PUBLIC INTEREST REVIEW FOR GROUND WATER APPLICATIONS

SUBJECT: Application G- 17489 Supersedes review of N/A
Date of Review(s)

A. GENERAL INFORMATION: Applicant's Name: James and Stuart Wilson County: Harney

A1. Applicant(s) seek(s) 2.0 cfs from one well(s) in the Malheur Lake Basin,
 _____ subbasin Quad Map: New Princeton

Oregon Water Resources Department Hydrograph for State Well HARN 1387, State Observation Well # 180

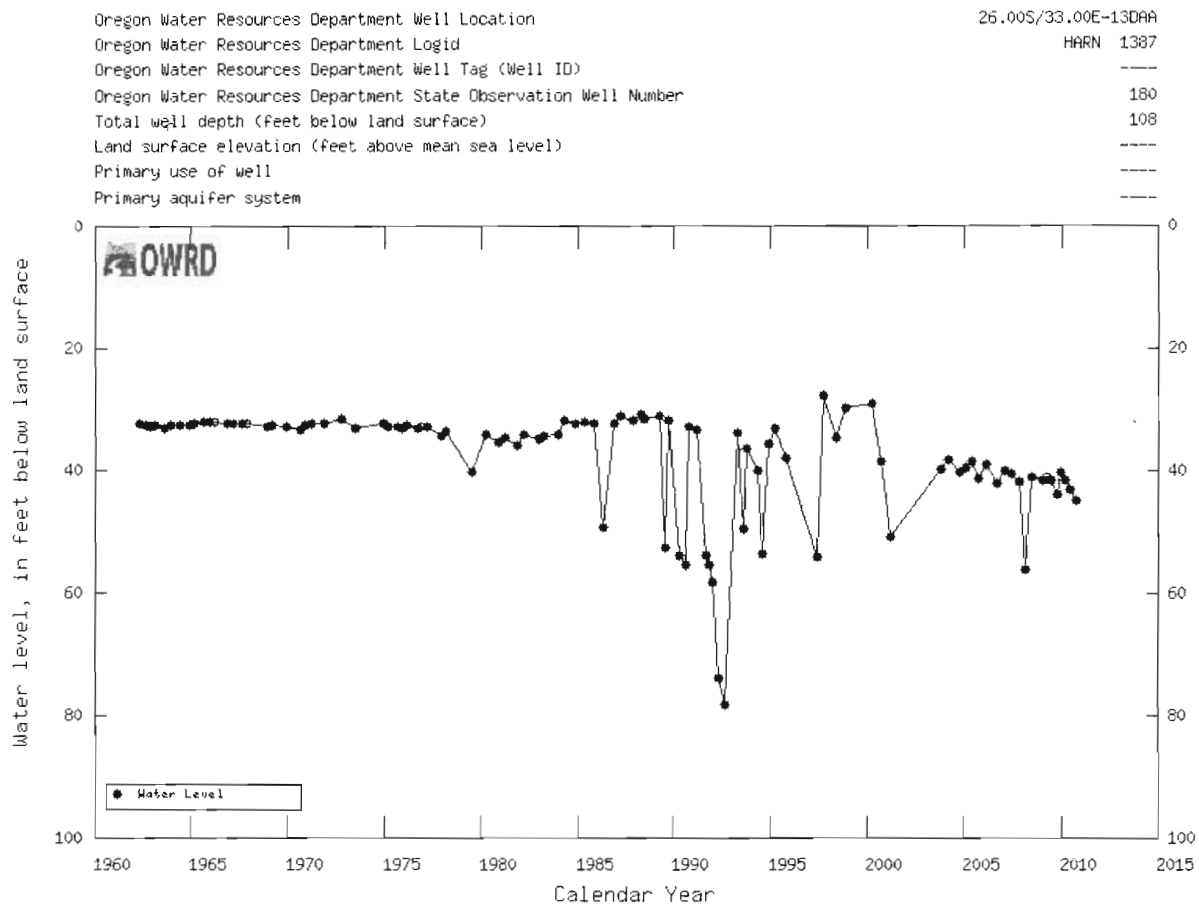
- B3 **Ground water availability remarks:** SOWs #183 and #180 are near the wells here. These wells are currently displaying small declines and "noise" such as recent or nearby pumping. In recent years, there has been some increased local concerns about water-level declines and pumping interference near Crane, about 10 miles north. Region Manager/Groundwater Section Manager Ivan Gall recommends use of Condition 7N in this basin.

- ☒ The permit should contain condition #(s) 7N;
 - ☐ The permit should be conditioned as indicated in item 2 below.
 - ☐ The permit should contain special condition(s) as indicated in item 3 below;
